PIC16C924 Rev. A Silicon Errata Sheet

The PIC16C924 (Rev. A) parts you have received conform functionally to the Device Data Sheet (DS30444D), except for the anomalies described below.

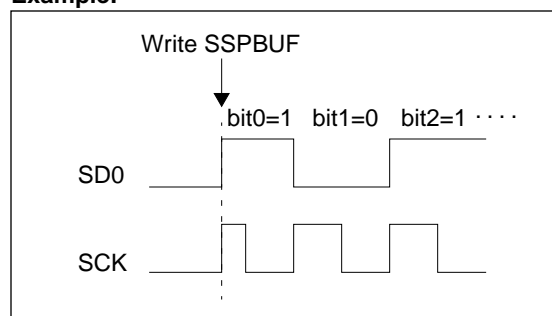
When the SSP is disabled, the PORTC data latch value is placed on the pins. The value in bit 3 of PORTC (SCK) should have the same value as the

idle state of SCK. For example, if the clock idles high, then bit 3 of PORTC must be set high. If bit 3 of PORTC is not configured the same as the idle state of the clock, you may experience an additional clock when the SPI is disabled then re-enabled.

Once the SSP module has been configured in SPI Master mode and one byte of data has been transmitted, wait for the interrupt flag bit SSPIF (PIR1<3>) or BF(SSPSTAT<0>) to be set. This indicates that the byte of data has been transmitted. Then, disable the SSP by clearing the SSPEN bit of the SSPCON register. Re-enable the SSP by setting the SSPEN bit. The SPI module will now transmit the next data byte written to SSPBUF.

FIGURE 1: WRITES TO TIMER1 (EXTERNAL CLOCK / OSCILLATOR MODE)

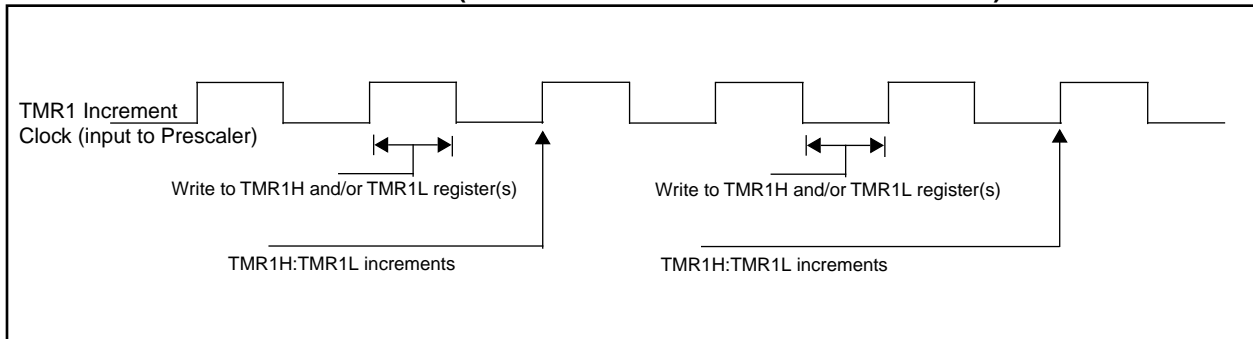
- a) The operation of Timer1 needs some clarification when the timer registers are written when the TMR1ON bit is set.

The internal clock signal that is the input to the TMR1 prescaler affects the incrementing of Timer1 (TMR1H:TMR1L registers and the Timer1 prescaler). When the Timer1 registers are NOT written, the Timer1 will increment on the rising edge of the TMR1 increment clock.

When the TMR1H and/or TMR1L registers are written while this clock is high, TMR1 will increment on the next rising edge of this clock.

When the TMR1H and/or TMR1L registers are written while this clock is low, TMR1 will not increment on the next rising edge of this clock, but must first have a falling clock and the rising clock for TMR1 to increment.

Figure 1 shows the two cases of writes to the TMR1H and/or TMR1L registers. Due to the V_{IH} and V_{IL} thresholds on the oscillator/clock pins, external Timer1 oscillator components, and external clock frequency, the Timer1 increment clock may not be of a 50% duty cycle.

The TMR1 increment clock is out of phase of the T1OSO/T1CKI pin by a small propagation delay.
